Re: Comment on the Surplus Plutonium Disposition (SPD) Draft Environmental Impact Statement (EIS)

Comment Documents and Responses—South Carolina

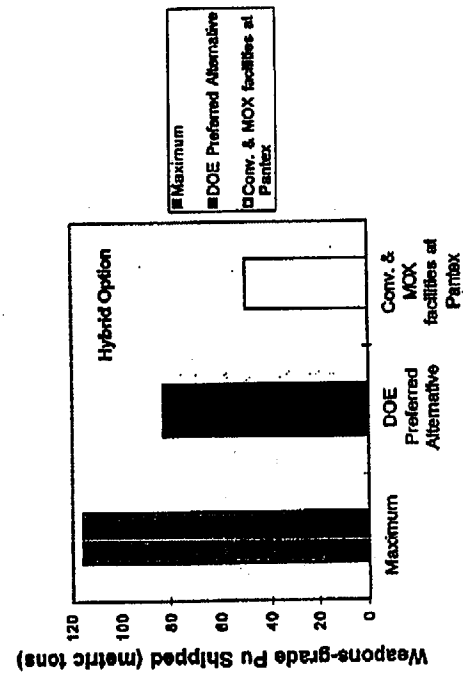
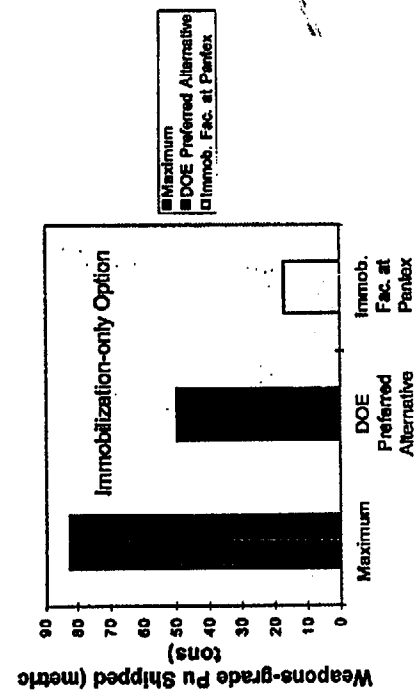
- Summary: If proliferation concerns associated with shipment of these materials is so great that a reduction of 33 1 in the amount to be shipped is sufficient to cause an otherwise reasonable alternative to be deemed unreasonable, then why is there no record that those alternatives leading to similar further reductions were given commensurate credit?

- The following bar charts are an effort to present this graphically. DOE deems the shipping reductions in going from the left bars to the middle bars as sufficient to make alternatives requiring the maximum shipment unreasonable, on the basis of the associated proliferation risk. But there is no evidence I can find that they value the equivalent further reduction in going from the middle to the right bars - which just happen to favor Ponce - as worth a tinkered dam.

DOE acknowledges the commentor's preference for Alternatives 9 or 10, which involve collocating pit conversion and MOX facilities at Pantex. The location of the immobilization facility was considered in the *Storage and Disposition PEIS*, and the ROD states DOE's strategy to immobilize at either Hanford or SRS. Therefore, this SPD EIS does not analyze immobilization at Pantex. Table L-6 shows the total transportation risks for all alternatives, including Alternatives 9 and 10. The transportation impacts for the preferred alternative, Alternative 3, are similar to Alternatives 9 and 10.
